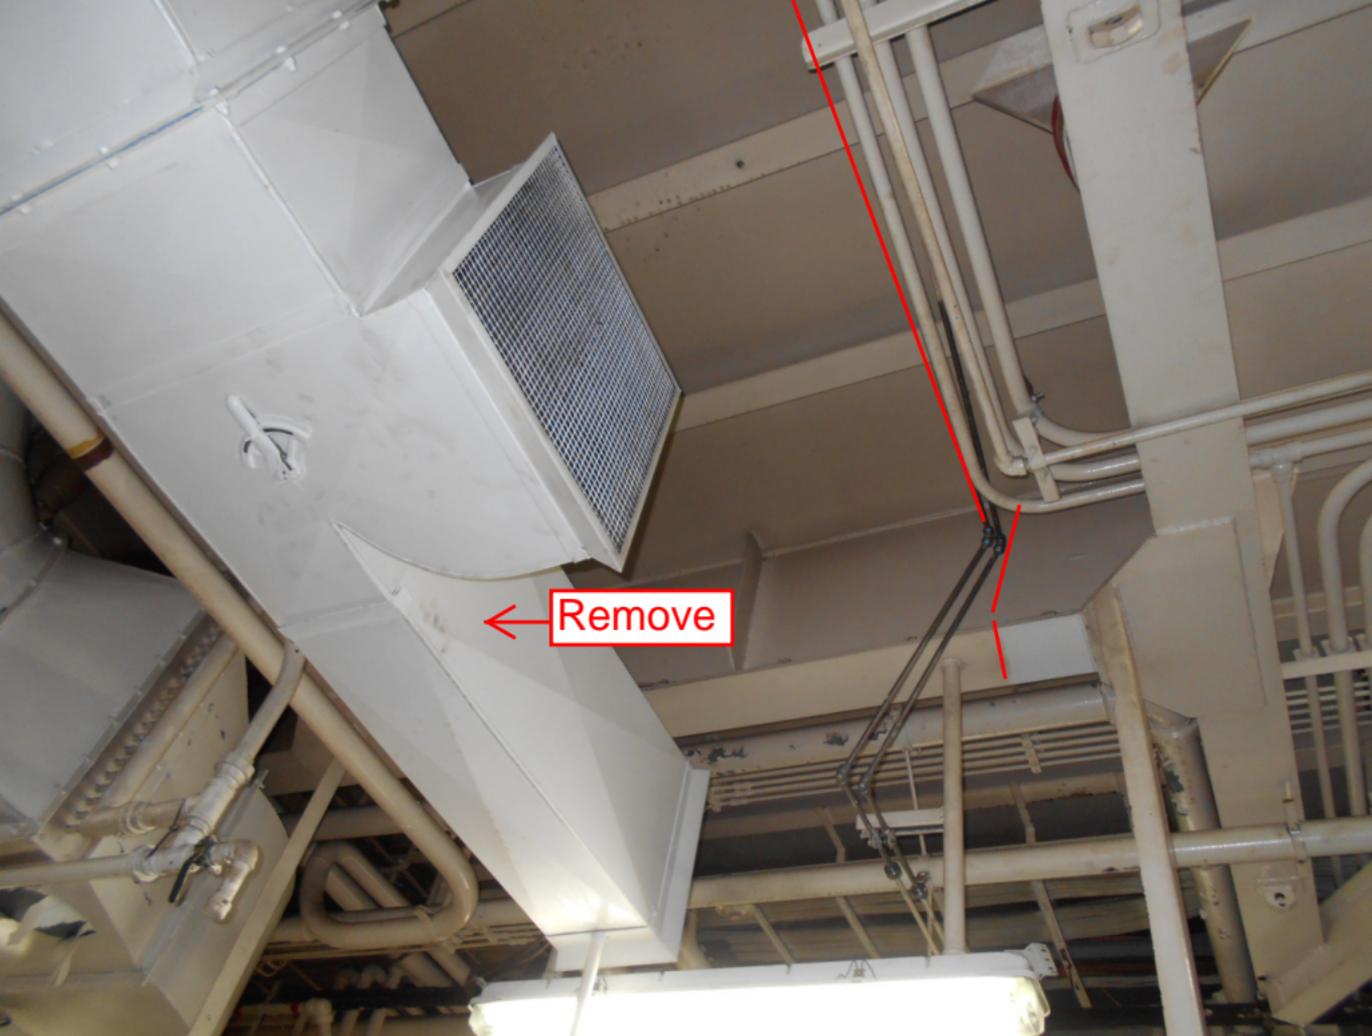
Winch Hydraulics

FM 200 Discharge

Potable Fill Line

#3 WB STBD Vent

cut zone

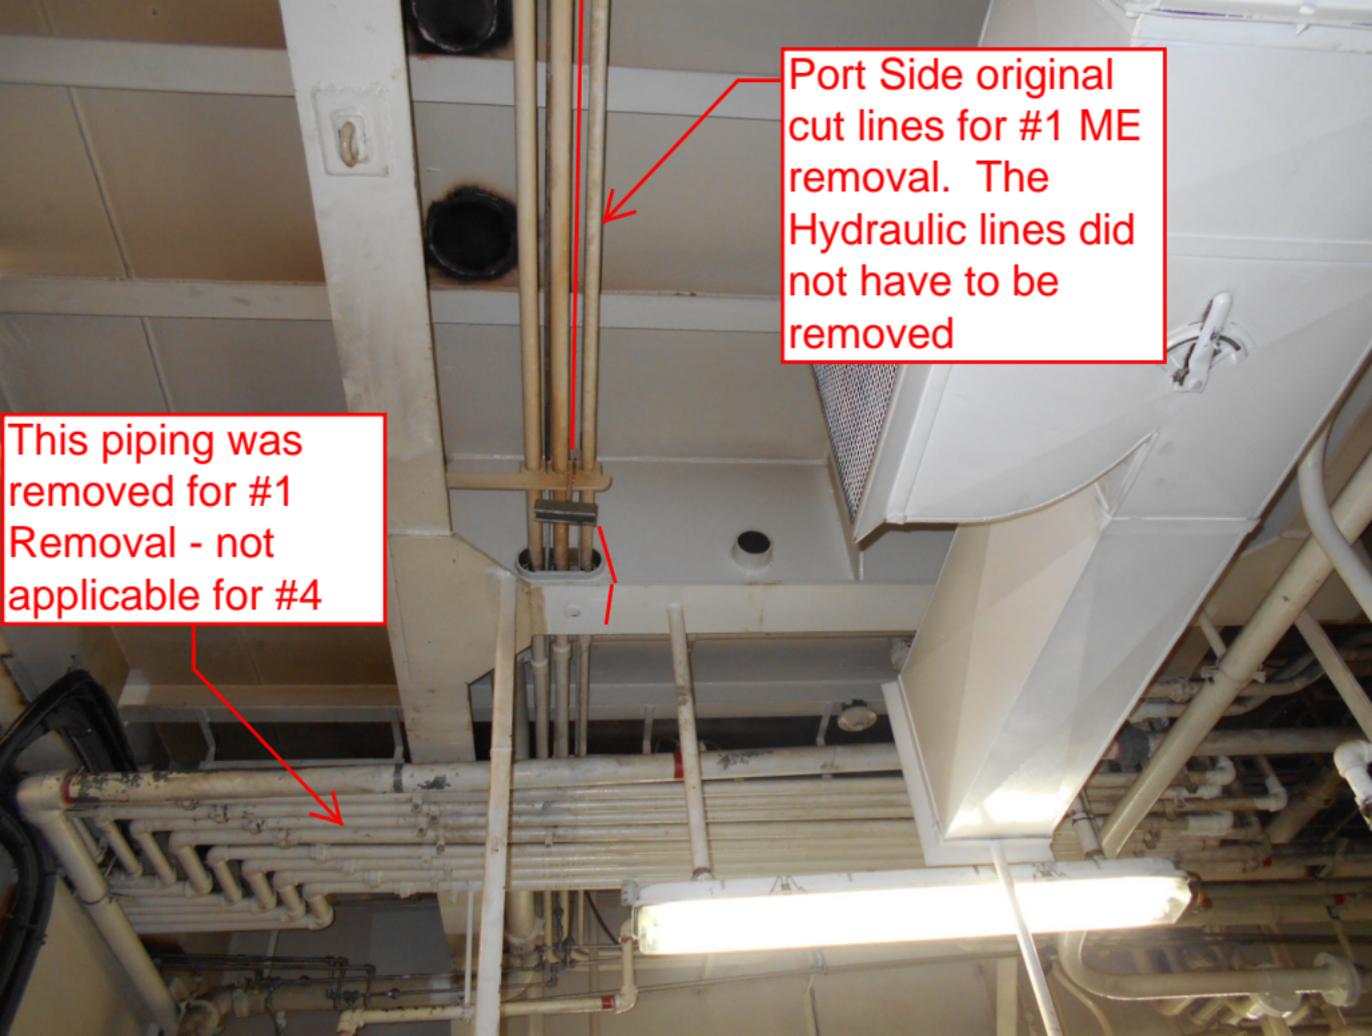
← Remove

Port Side original cut lines for #1 ME removal. The Hydraulic lines did not have to be removed

This piping was removed for #1 Removal - not applicable for #4

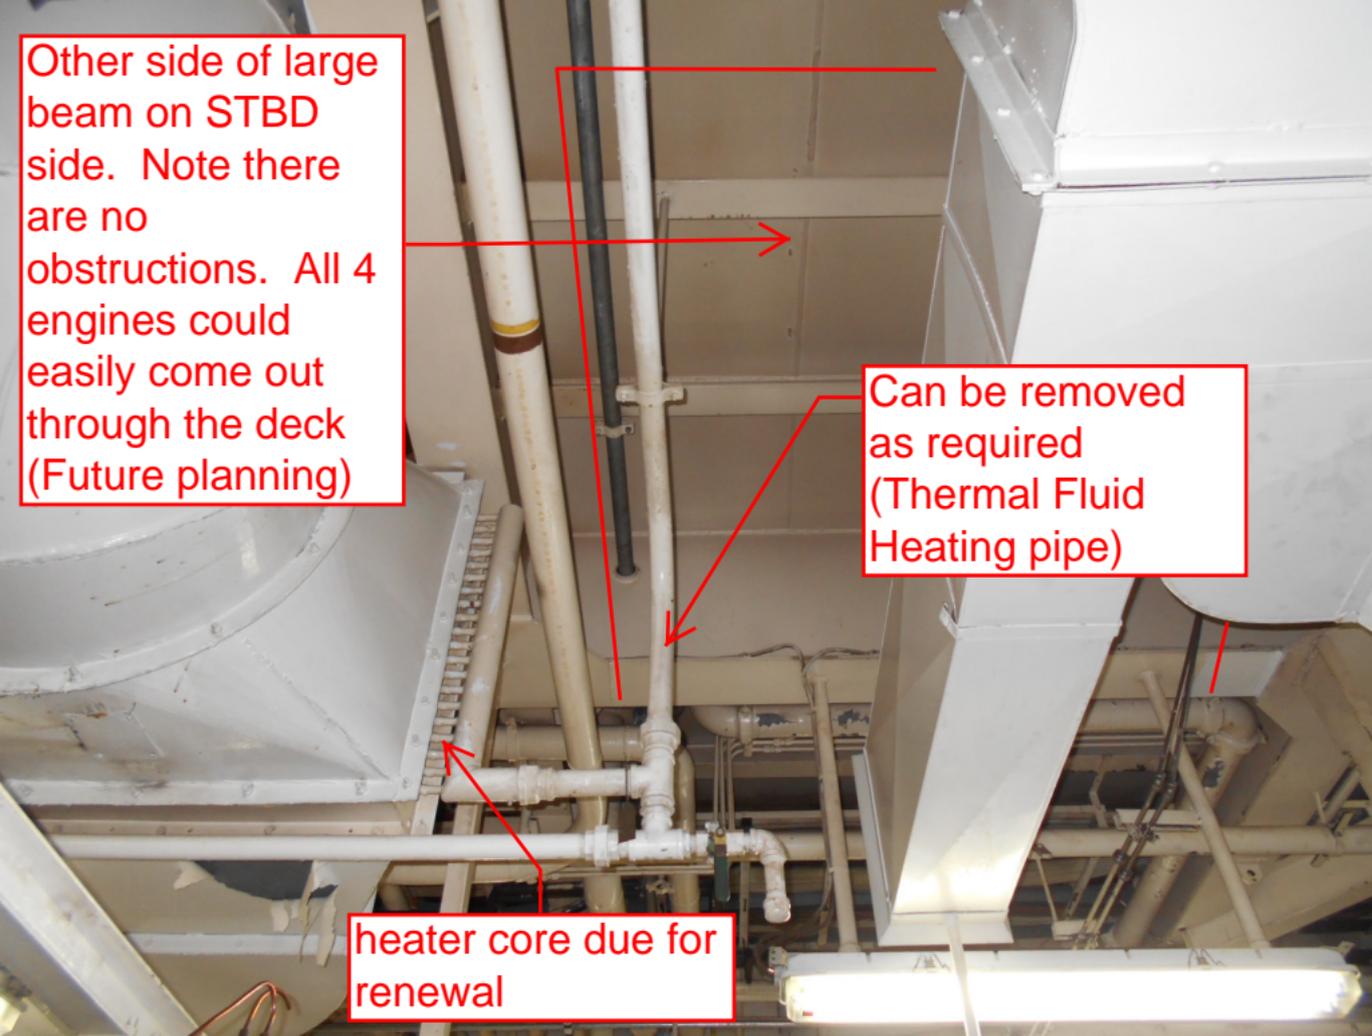
Other side of large beam on STBD side. Note there are no obstructions. All 4 engines could easily come out through the deck (Future planning)

Can be removed as required (Thermal Fluid Heating pipe)

heater core due for renewal

FM200 pipe is all welded, unlike the one above #1. Should be cut and threaded and union installed for future engine removals
